UNITED STATES PATENT AND TRADEMARK OFFICE

APPLICATION NO.	FILING DATE	FIRST NAMED INVENTOR	ATTORNEY DOCKET NO.	CONFIRMATION NO.
10/764,105	01/23/2004	Cong Thanh Dinh	577-614	7912
23869	7590	11/04/2005	EXAMINER	
HOFFMANN & BARON, LLP 6900 JERICHO TURNPIKE SYOSSET, NY 11791			PATEL, DHIRUBHAI R	
			ART UNIT	PAPER NUMBER
			2831

Office Action Summary

SKETCH "A"

Fig. 3

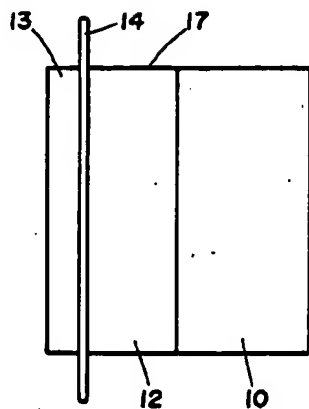
Regarding claim 8, a bracket (see sketch A) for attachment to an electrical outlet box 10 having a back wall, a side wall upstanding from and perimetrically bounding said back wall so as to define a box interior and an open face opposite said back wall (see figs 3-5, column 2 lines 65-68, column 3 lines 1-5), said bracket comprising: a generally planar flange 14 (see fig 5) positionable on an upper edge of said side wall (see fig 5) for spanning said open face of said box (see column 2 lines 38-68, column 3 lines 1-45), said planar flange having an opening therethrough (see fig 5) for accessing said box interior, said opening being bounded by a first extending wall 23 (see figs 3-5), said first extending wall extending a first distance and in a first direction from said planar flange and a second extending wall 12 extending a second distance and in a second direction from said planar flange (see fig 5, column 3 lines 1-5), said first distance being different from said second distance and said first direction being opposite said second direction (see figs 3-5, and column 3 lines 1-5).

Regarding claim 9, said first distance approximates the thickness of a first wall board and said second distance approximates the thickness of a second wall board of different thickness (see figs 3-5, column 3 lines 1-5).

Regarding claim 10, one of said first and second extending walls is positioned to extend into said box interior (see figs 3-5).

Fig. 5

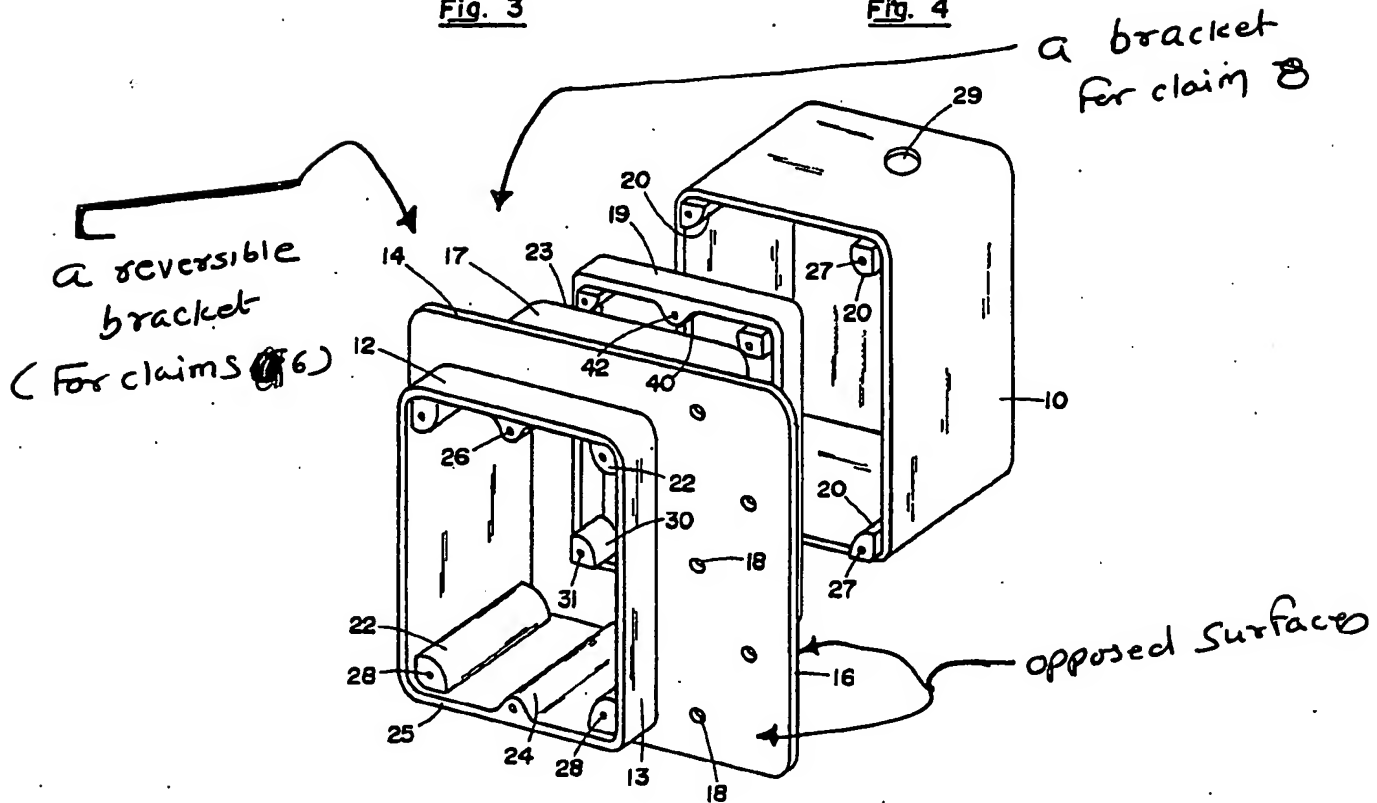
Regarding claims 6-7, reversible bracket (see sketch A) for attachment to an open front face of an outlet box 10 comprising (see fig 5): a planar flange 14 having opposed surfaces having a first position with one of said opposed surfaces being attachable to said open front face of said box (see figs 3-5, column 2 lines 65-68, column 3 lines 1-5 and sketch A) and a reversible second position with the other of said opposed surfaces being attachable to said open front face of said box (see figs 3-5, column 2 lines 65-68, column 3 lines 1-5 and sketch A); and a bounded access member 12 extending through said flange (see fig 5), said access member having an opening extending through said flange between opposite extending rims 23, 25 of said access member (see fig 5), one of said rims 23 being located a first distance from said open front face of said box when said flange is in said first position (see fig 5), and the other of said rims 25 being located at a second distance from said open front face of said box when said flange is in said reversible second position (see fig 5), and said first distance being

different from and said second distance (see fig 5). With respect to claim 7, It is noted that the assembly of McNab meet the structural limitations.

Regarding claims 11-12, a method of attaching an electrical outlet box, having a box interior and an open front face, to a stud (see column 3 lines 45-50) comprising the step of: providing a bracket (see sketch A) having a generally planar flange 14 and an opening therethrough (see fig 5), said opening being bounded by a first extending wall 23 (see fig 5) extending from said flange a first direction, and a second extending wall 12 extending from said flange a second distance in a second opposite direction (see fig 5), and first distance being different from said second distance (see fig 5, column 3 lines 1-5); attaching said bracket to said electrical outlet box over said open front face with one of said first or second extending walls extending into said box interior (see figs 3-4, column 2 lines 38-68); and attaching said box to said stud such that said other of said first or second extending wall extends outwardly from said face of said stud (see column 3 lines 45-50). With respect to claim 12, it is noted that the assembly of McNab meet the structural limitations.
